Technical Service Bulletin: TSB150164

Optional One-Piece Eliminator™ Centrifugal Oil Filter Upgrade

Description of Change

Figure 1, Centrifugal Oil Filter with Alfa Laval Disc Stack

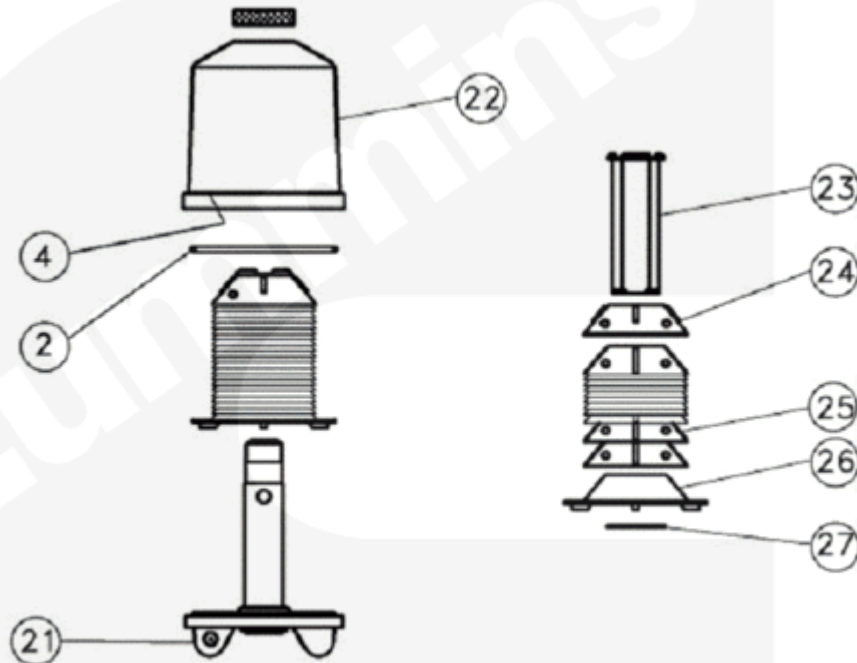
This document announces the release of a new Cummins Filtration™ one-piece Eliminator™ centrifugal oil filter with SpiraTec™ technology.

The new Cummins Filtration™ one-piece Eliminator™ centrifugal oil filter with SpiraTec™ technology is a fully disposable and sealed unit that contains the filtering element and bushings. This requires no cleaning as the centrifugal oil filter is just replaced. To prevent premature bushing wear on the Alfa Laval™ disc stack, Cummins Inc. recommends the use of the new Cummins Filtration™ one-piece Eliminator™ centrifugal oil filter with SpiraTec™ technology in all Eliminator™ systems.

The new upgraded one-piece centrifugal oil filter is backwards compatible.

Note : If the one-piece centrifuge is fitted to an engine that has previously had a restrictor orifice fitted to the centrifuge shaft, the restrictor must be removed. It can be removed from the shaft with a hex key.
